### Proposed Revisions to a Standard Plans Index

Index Number: 400-010

Index Title: Cantilever Retaining Wall (C-I-P)

TYPICAL BACKFILL DETAIL

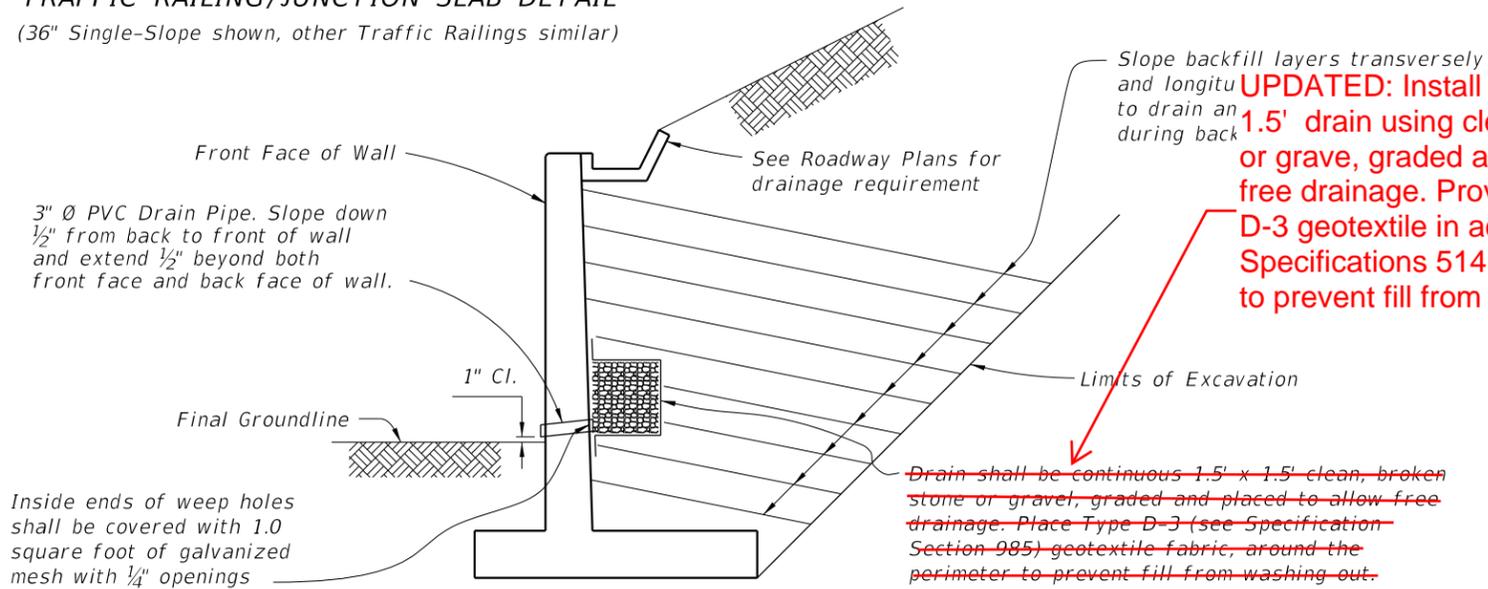
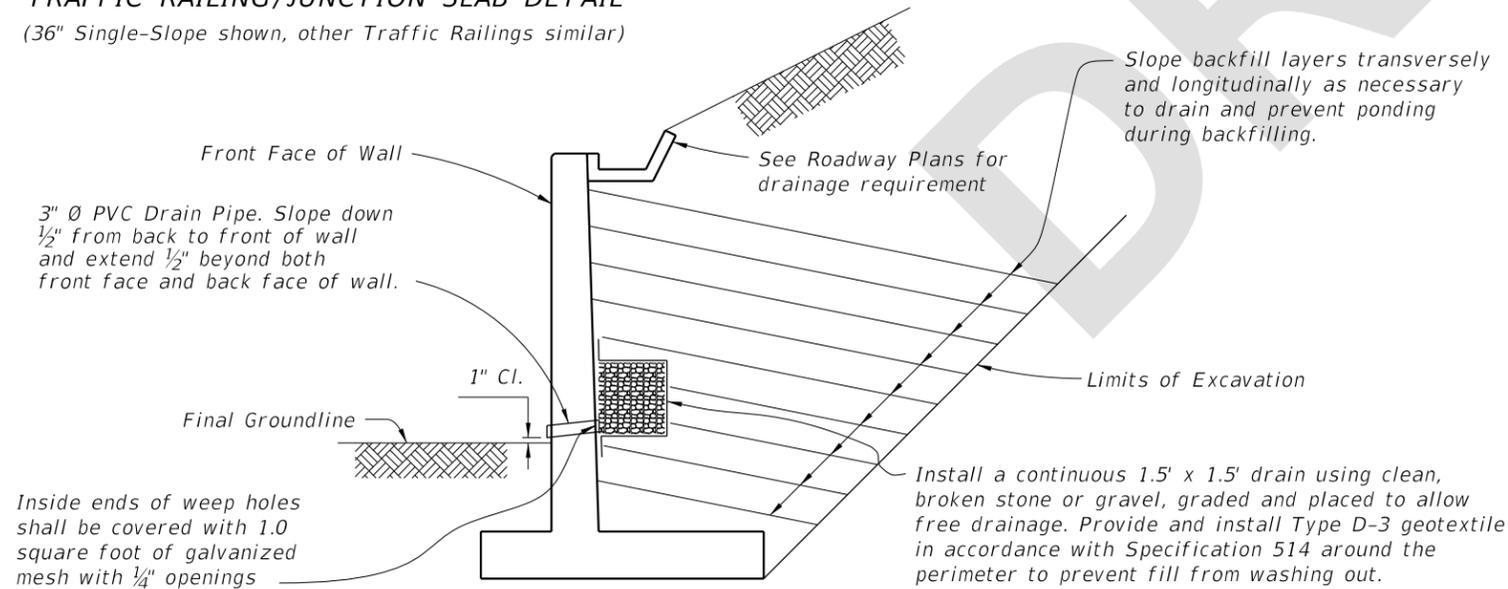
Sheet 2: Updated the TYPICAL BACK-FILL DETAIL Callout: " Install a continuous 1.5' x 1.5' drain using clean, broken stone or grave, graded and placed to allow free drainage. Provide and install Type D-3 geotextile in accordance with Specifications 514 around th perimeter to prevent fill from washing out."

SECTION A-A  
EXPANSION JOINT DETAIL

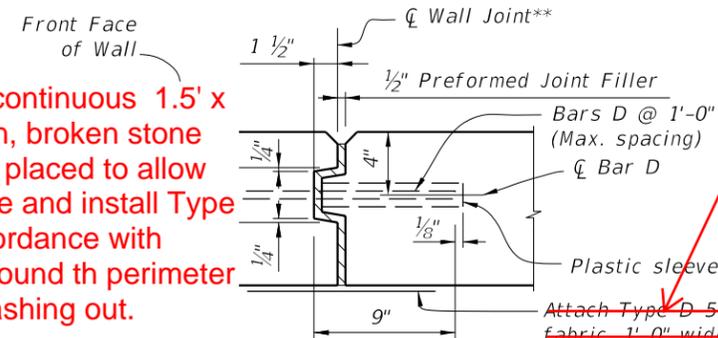
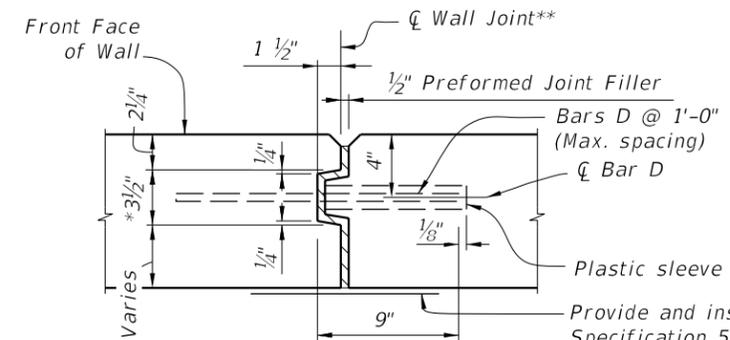
Updated the EXPANSION JOIND DETAIL (SECTION A-A) Callout: "Provide and install Type D-5 geotextile in accordance with Specifications 514. Attach geotextile, 1'-0" wide and full height to fill, to the back of wall with an adhesive approved by the Engineer."

~~Attach Type D-5 (see Specification Section 985) Geotextile fabric, 1' 0" wide and full height of fill, to the back of wall with an adhesive approved by the Engineer.~~

**UPDATED; Provide and install Type D-5 geotextile in accordance with Specifications 514. Attach geotextile, 1'-0" wide and full height to fill, to the back of wall with an adhesive approved by the Engineer**
